TECHNICAL NOTE

Project: Erection of New Lidl Foodstore (Use Class E) with associated car parking and landscaping

Application: 135647/FO/2022

Ref: SCP/220122/TN01

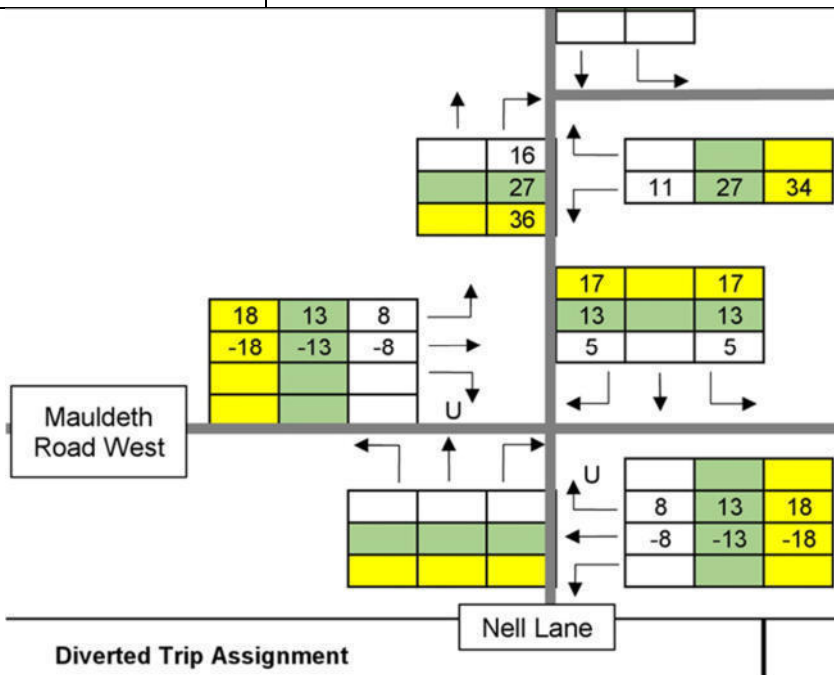
TfGM Comments	SCP Response
I	Existing office trip generation should have been determined by surveying the site rather than a desktop academic exercise. TfGM HFAS suggests – as a sensitivity test – that the assessments are revised to include a 50% “new” trip distribution.	The existing office use is no longer in operation and it was not possible to survey peak hour activity under typical conditions. This has been undertaken as requested. The turning movements illustrated at Appendix 4 provide a comparison between the flows as submitted in the Transport Assessment and those modelled within this exercise. The full revised traffic flow model is provided at Appendix 5.
II	Trip Distribution. TfGM question the 50:50 split for diverted traffic when the baseline flows are not split evenly.	We have examined this in detail and have found that any alteration to the split of diverted traffic will have a de minimis effect on peak hour turning movements. The extract of traffic figure 9 from Appendix 5 to this note (see below) confirms that there are fewer than 20 diverted trips in the weekday AM peak and fewer than 30 in the PM. We have not made any adjustment to these assumptions.

The diagram illustrates the diverted trip assignment at the intersection of Mauldeth Road West and Nell Lane. It shows several traffic flow matrices with numerical values and arrows indicating movement directions. The matrices are color-coded: yellow for through movements, green for turning movements, and white for U-turns. The diagram is labeled 'Diverted Trip Assignment' at the bottom.		
III	Committed development.	Not applicable.
IV	LinSig Modelling.	We have made the recommended adjustments to the model including:- i) Give-way data ii) Lane lengths iii) Cruise times iv) Phase delays

v) Effect of trams The revised LinSig model and its output will be provided separately via email to both authorities for verification. We have only undertaken the above “sensitivity test” for the Base 2028 + Lidl scenarios. For ease of comparison with the results provided in the submitted TA, the following tables illustrate the difference that the amendments to the model requested by TfGM have had on the network’s operation. We have only summarised results for the Nell Lane junction in the following tables, but the results for the full network are provided within the LinSig outputs appended as stated above. Tables 1 and 2 below summarise the comparison between the submitted LinSig output within the TA and that resulting from the revised modelling for the base network at both 2023 and 2028. The adjustments to the model have had little effect on the overall performance of the Nell Lane junction; they marginally worsen the practical reserve capacity in the AM peak, but improve the PRCs for both the PM and the Saturday. Tables 3 and 4 compare the results of the base plus Lidl scenario modelling at 2028 as-submitted and as-revised. There is a marginal worsening of performance in the AM peak, mainly due to Nell Lane (S), but otherwise, the results are effectively identical.

Drawing Title	SWEPT PATH OF MAX. LEGAL ARTICULATED HGV TURNING LEFT INTO NELL LANE FROM MAULDETH ROAD WEST AND INTO SITE ACCESS
---------------	---

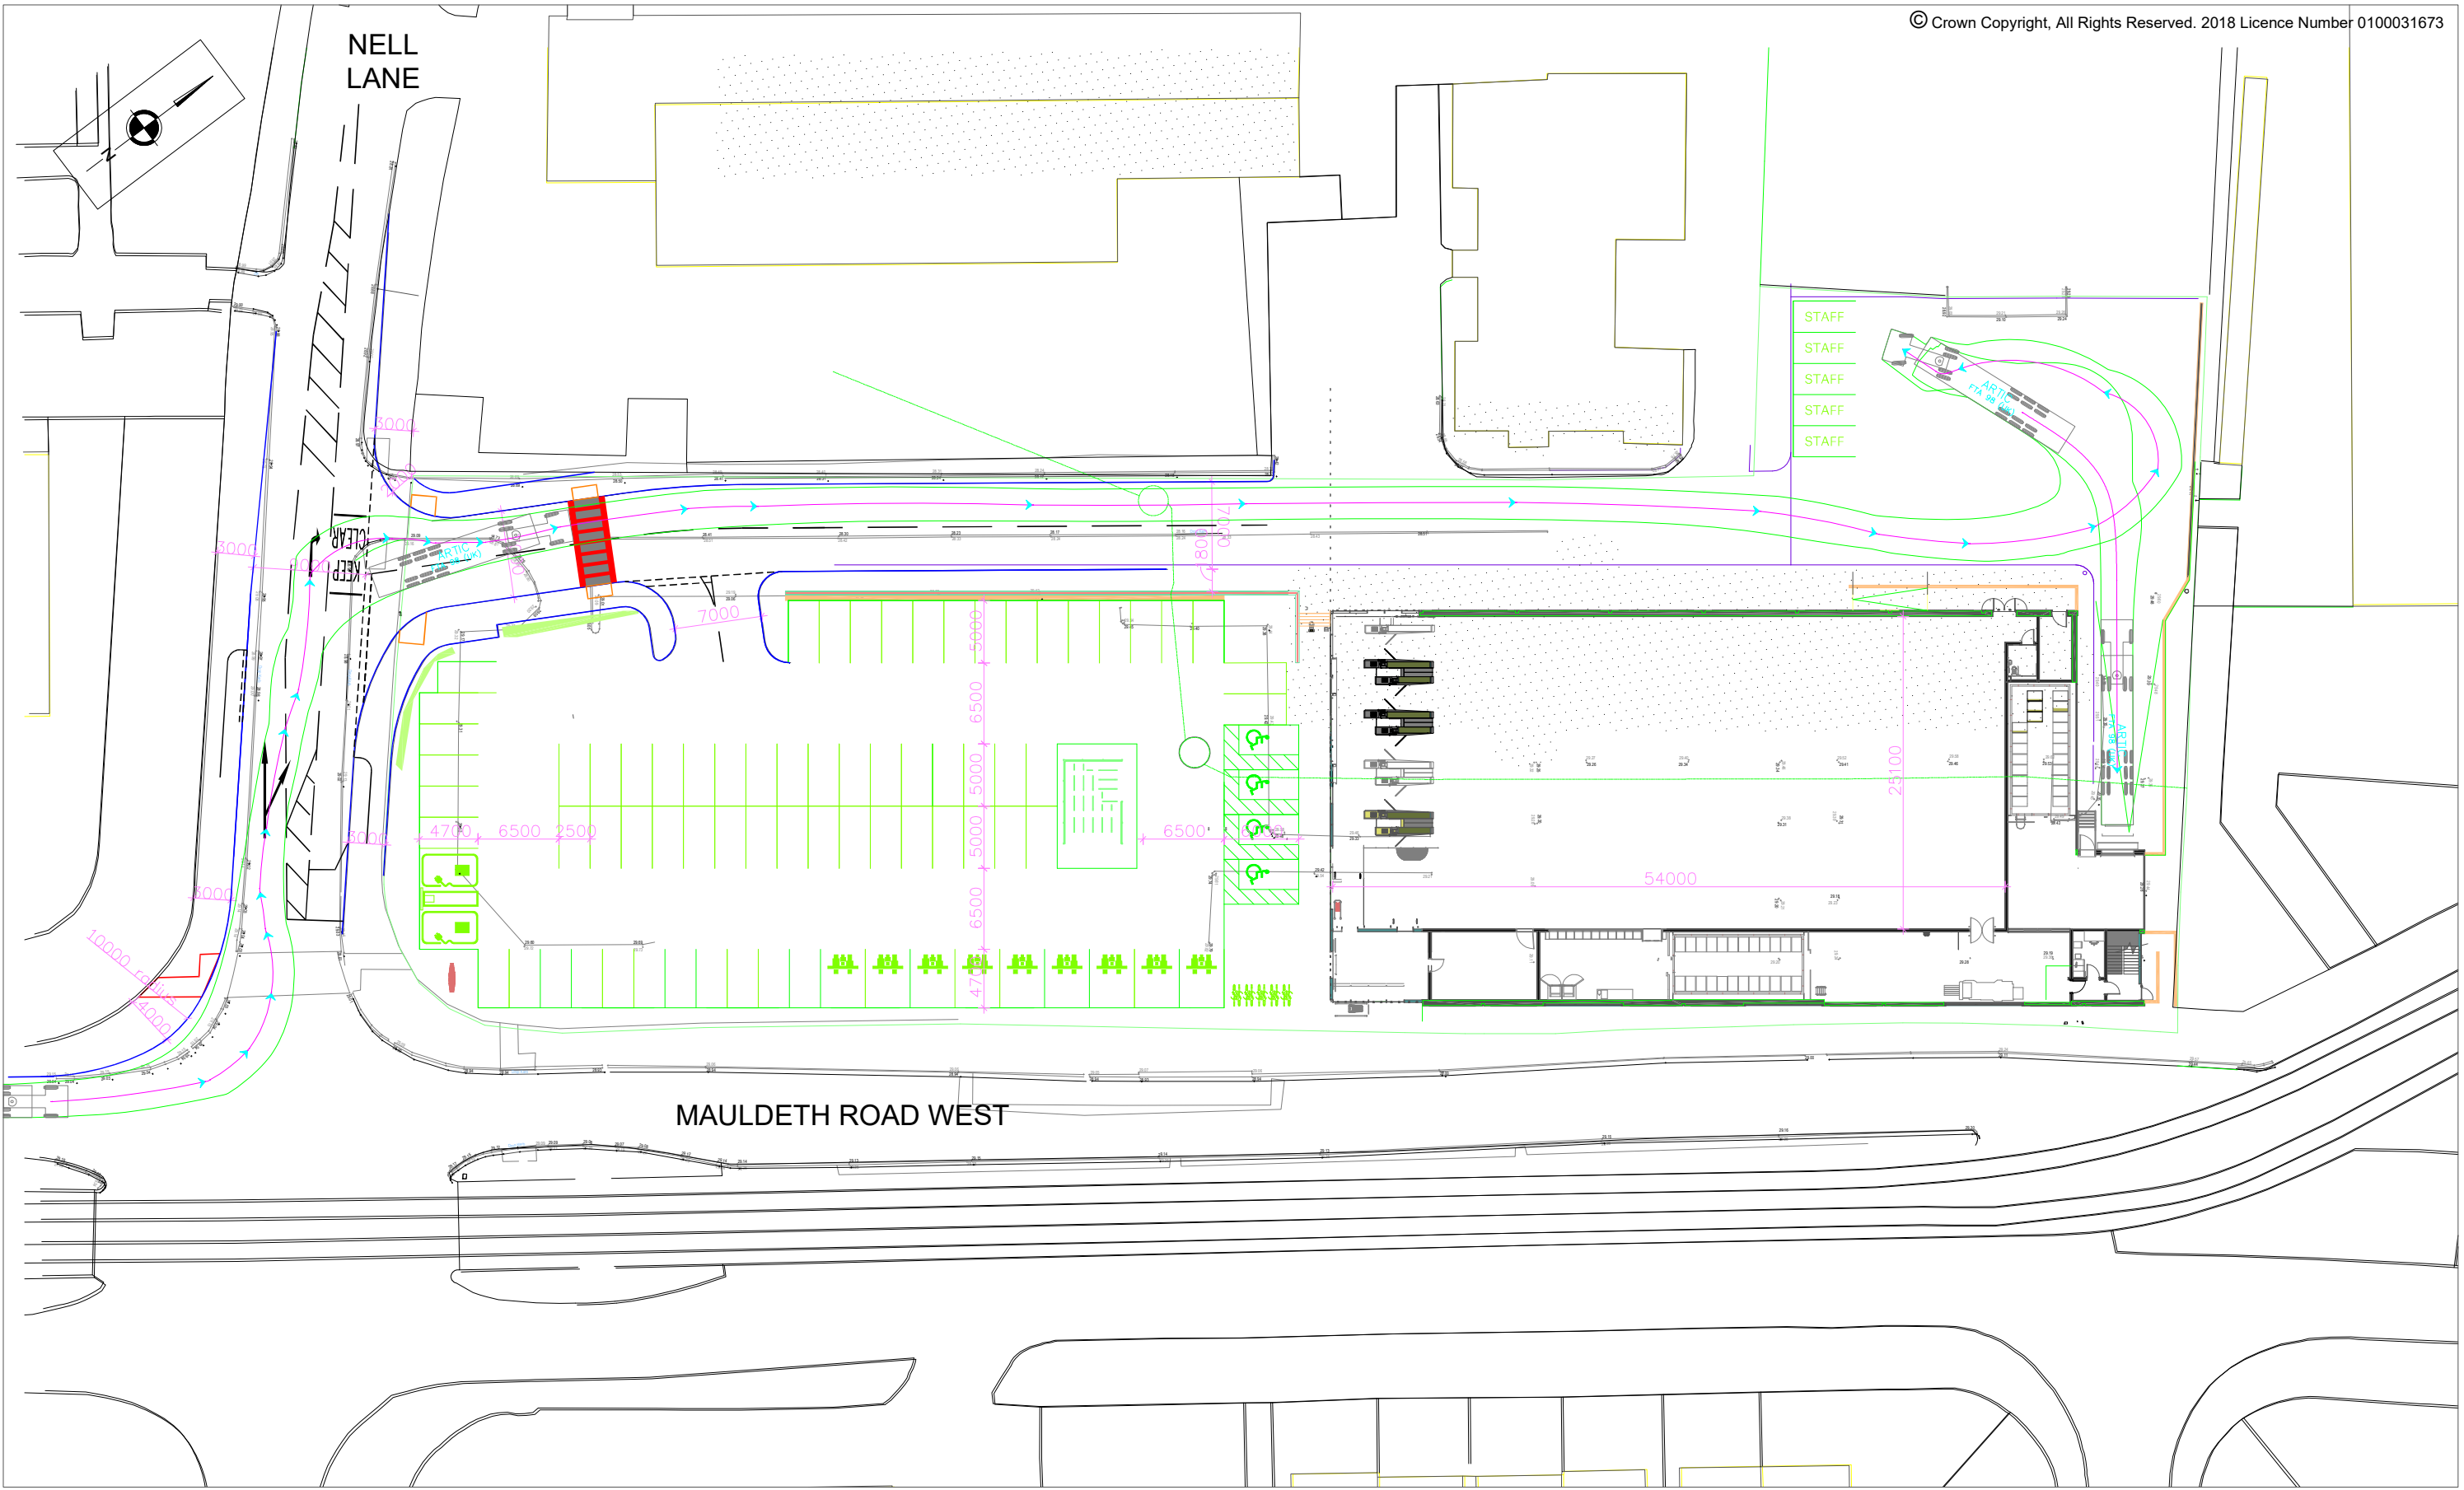
The swept path plans show that the 'max-legal' vehicle will overrun conflicting lanes.

Problem Location Plan

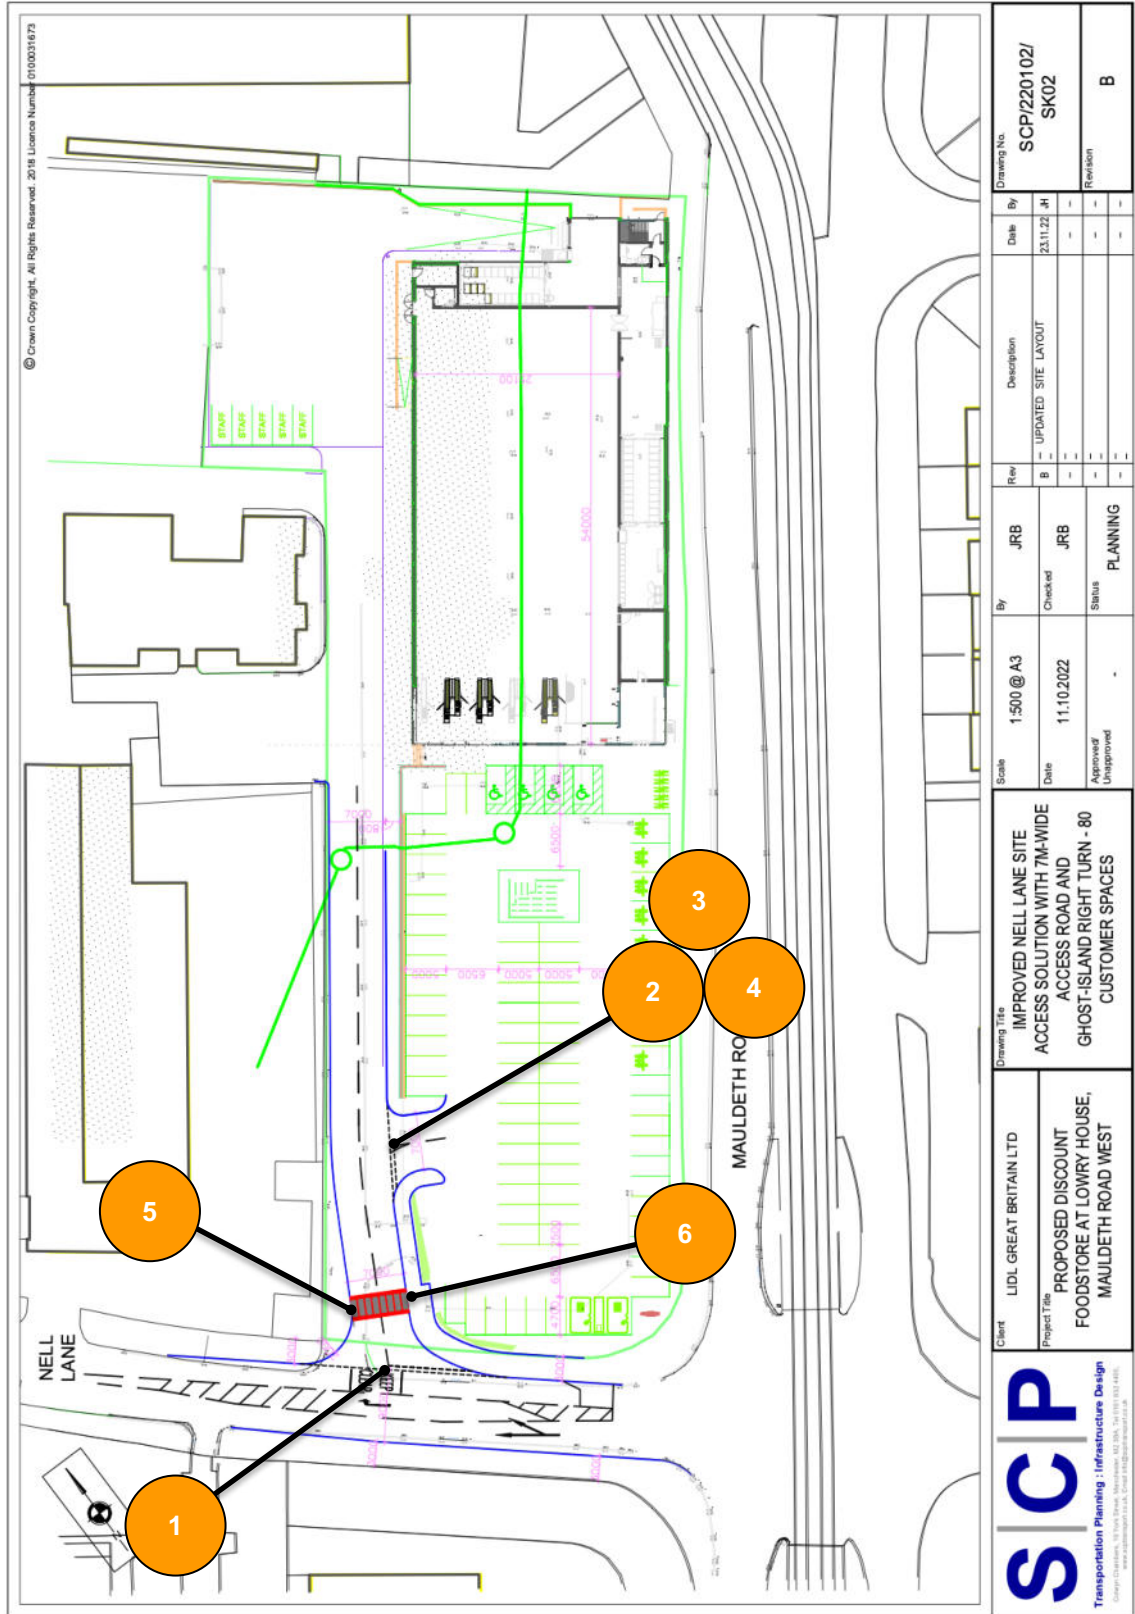
PROBLEM	1
Location	Proposed development access road junction, Nell Lane (Drwg No. SCP/220102/SK02 Rev B)
Summary	Increased risk of vehicles striking kerbs, pedestrians on adjacent footway areas or using the proposed crossing facility.
The scheme proposals include the introduction of a new ghost right-turn facility into the development access road. At this stage of audit, vehicle swept paths have not been provided for this junction. It is unclear from this information provided whether the relevant design vehicles that may use this junction can safely carry out their turning movements without hitting kerbs. This may increase the risk of kerb strikes and vehicle to pedestrian type collisions.	
RECOMMENDATION	
The Audit Team recommend vehicle swept paths are carried out for all turning movements for Design Vehicles that are likely to be using the proposed development junction. The vehicle swept paths should be safely accommodated within the available carriageway area without overrunning adjacent footway areas.

PROBLEM	2
Location	Proposed development access junction (Drwg No. SCP/220102/SK02 Rev B)
Summary	Increased risk of vehicles striking kerbs, pedestrians on adjacent footway areas or using the proposed crossing facility.
The scheme proposals include the introduction of a priority junction into the development site. At this stage of audit, vehicle swept paths have not been provided for this junction. It is unclear from the information provided whether the relevant design vehicles that may use this junction can safely carry out their turning movements without hitting kerbs. This may increase the risk of kerb strikes and vehicle to pedestrian type collisions.	
RECOMMENDATION	
The Audit Team recommend vehicle swept paths are carried out for all turning movements for Design Vehicles that are likely to be using the proposed development junction. The vehicle swept paths should be safely accommodated within the available carriageway area without overrunning adjacent footway areas.

PROBLEM	3
Location	Development access junction (Drwg No. SCP/220102/SK02 Rev B)
Summary	Pull out type collisions.
The site visit has established that there is a significant level difference between the development access road carriageway and the proposed development site. Vehicles waiting to emerge onto the access road from a standing start could experience difficulties due to the difference in levels. This could impact upon a driver's ability to see clearly when looking to the left and right on approach to the junction exit and may increase the risk of vehicle to vehicle or vehicle to pedestrian pull out type collisions.	
RECOMMENDATION	
The Audit Team recommend that at the detailed design stage a dwell/plateau should be provided for the development site junction where it meets the development access road.

PROBLEM	4
Location	Development access junction (Drwg No. SCP/220102/SK02 Rev B)
Summary	Reduced visibility splay may increase the risk of vehicle pull-out type collisions.
The scheme drawings do not indicate a proposed visibility splay. The site visit has established that the achievable visibility splays may be impacted upon by the presence of vegetation along the eastern kerblines and the existing ground level. A lack of visibility at the junction may increase the risk of pull out type collisions.	
RECOMMENDATION	
The Audit Team recommend that the achievable visibility splays are not compromised.

PROBLEM	5
Location	Proposed pedestrian crossing facility, development access road (Drwg No. SCP/220102/SK02 Rev B)
Summary	Compromised pedestrian to driver intervisibility may result in vehicle to pedestrian type collisions.
The site visit has established that the pedestrian to driver intervisibility when looking to the right from the northern kerblines of the proposed pedestrian crossing facility may be impacted upon by the presence of vegetation. A lack of intervisibility to the right may increase the risk of pedestrians crossing into the path of vehicles entering the development site access road and sustaining injury.	
RECOMMENDATION	
The Audit Team recommend that adequate and compliant pedestrian to driver intervisibility splay is achieved for pedestrians crossing the development access road from the northern footway.

PROBLEM	6
Location	Proposed pedestrian crossing facility, development access road (Drwg No. SCP/220102/SK02 Rev B)
Summary	Compromised pedestrian to driver intervisibility may result in vehicle to pedestrian type collisions.
The site visit has established that the pedestrian to driver intervisibility when looking to the left and right from the southern kerbline of the proposed pedestrian crossing facility may be impacted upon by the existing ground level and vegetation. A lack of intervisibility to the left and right may increase the risk of pedestrians crossing into the path of vehicles entering the development site access road and sustaining injury.	
RECOMMENDATION	
The Audit Team recommend that adequate and compliant pedestrian to driver intervisibility splay is achieved for pedestrians crossing the development access road from the southern footway.

4	Request for Stage 1 RSA pre-planning.	The Stage 1 RSA is provided at Appendix 3 to this note. Five issues were raised at the Stage 1 audit, our Designer's Response to these items is as follows:- <u>Designer's Response to Stage 1 RSA (see Appendix 3)</u> 1. Swept paths at the realigned site access junction onto Nell Lane had not been provided. These were provided within the submitted TA and confirm that all swept paths can be undertaken without risk of kerb strikes or danger to pedestrians. 2. Swept paths of the design vehicle at the car park entrance from the site access road. We assume that the auditor was unaware that the HGV would service the store via the rear service yard and not via the customer car park as is more typical of Lidl arrangements. Therefore, no need to track this access with a design HGV. 3. The auditor identified a significant level difference between the existing site and Nell Lane. This level difference will be removed as part of Lidl's proposals and the site access will emerge onto Nell Lane at a similar height. There is therefore no need for any dwell plateau, as suggested by the auditor. 4. The auditor identified a lack of a visibility splay and a presence of boundary vegetation. The visi splay is now shown on the drawings provided at Appendix 2 and there will be no boundary vegetation to obstruct visibility in this location. 5. The auditor identified a potential pedestrian/vehicle intervisibility issue at the proposed raised crossing of the site access road. This raised crossing has now been relocated further into the access road where more than sufficient ped/veh intervisibility is available. The uncontrolled crossing at the realigned bellmouth has been repositioned on SK04 such that adequate ped/veh intervisibility is now provided.

Base 2028 + Lidl (assuming 50% new and 50% secondary – as requested by TfGM)

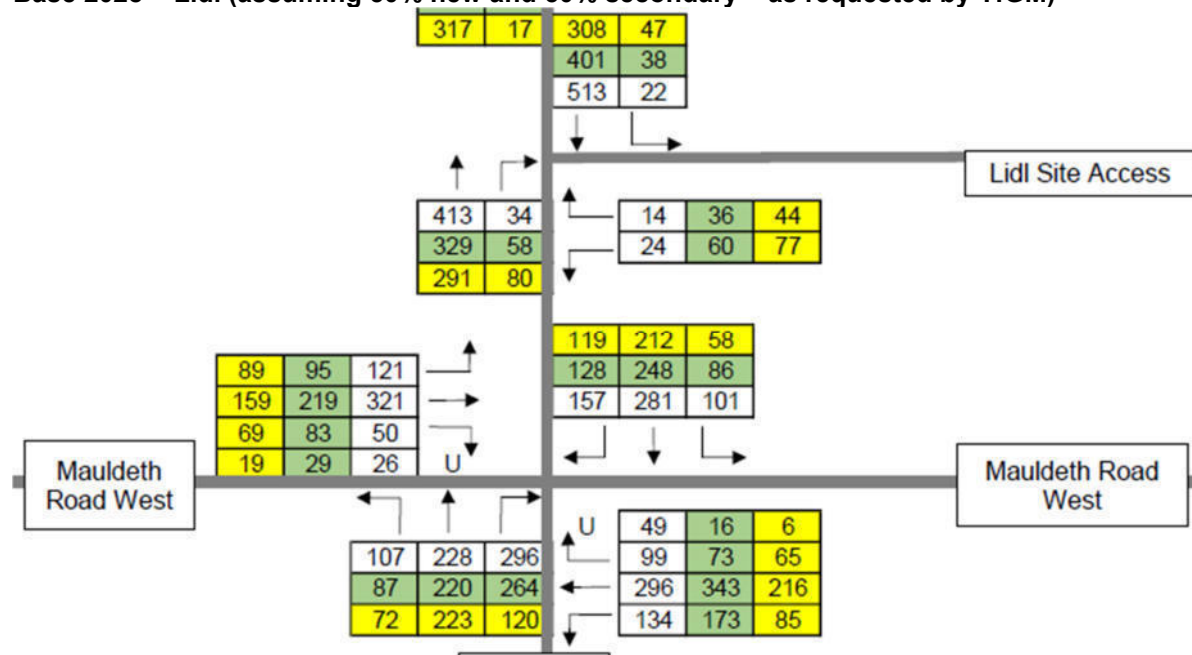
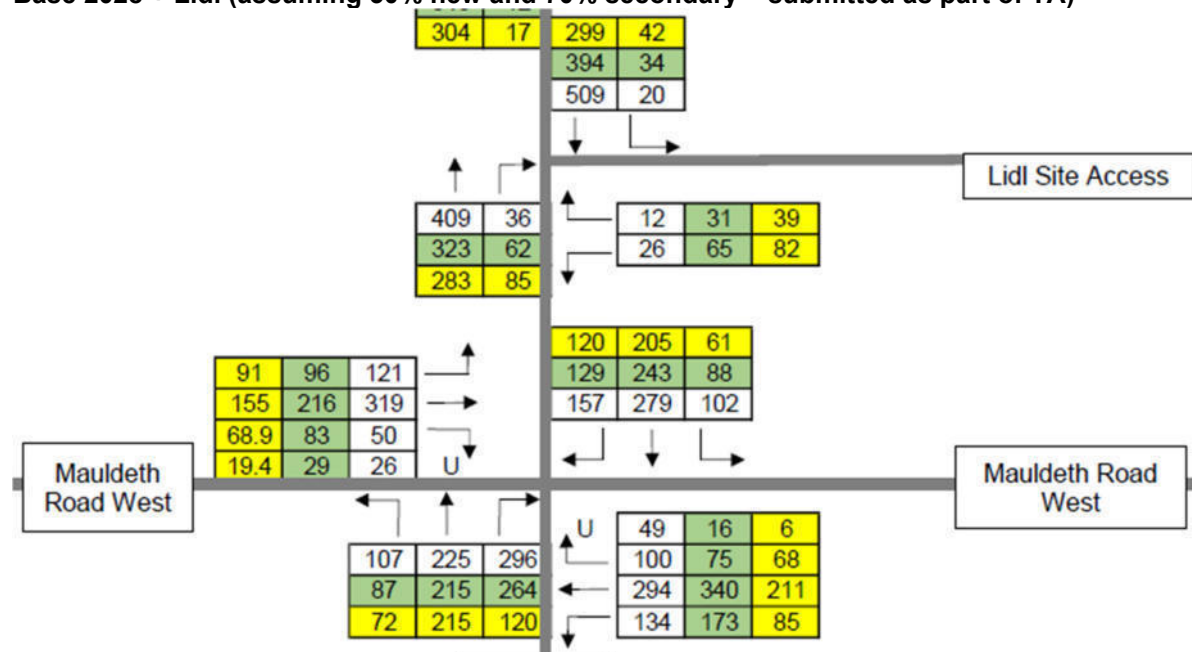
The TA states that, *“These are trips that are already on the network as part of a primary trip. Given that the site is on a main route along Mauldeth Road West and Nell Lane, the store may act as a convenience store for commuters on their way to/from work.”* TfGM would highlight that whilst this may be representative of weekdays, it would not be accurate for Saturdays, as there would be less existing commuting trips compared to the weekday. TfGM HFAS therefore consider that it is incorrect to apply the same trip type percentages for a weekday and a Saturday peak. In light of this, TfGM HFAS suggest that a sensitivity test is undertaken with 50% new trips applied during all scenarios: weekday and Saturday.

Below is a comparison between the Base 2028 + Lidl scenario submitted as part of the TA and the updated Base 2028 + Lidl scenario which assumes 50% new and 50% secondary. For reference, the previous assumption was 30% new and 70% secondary.
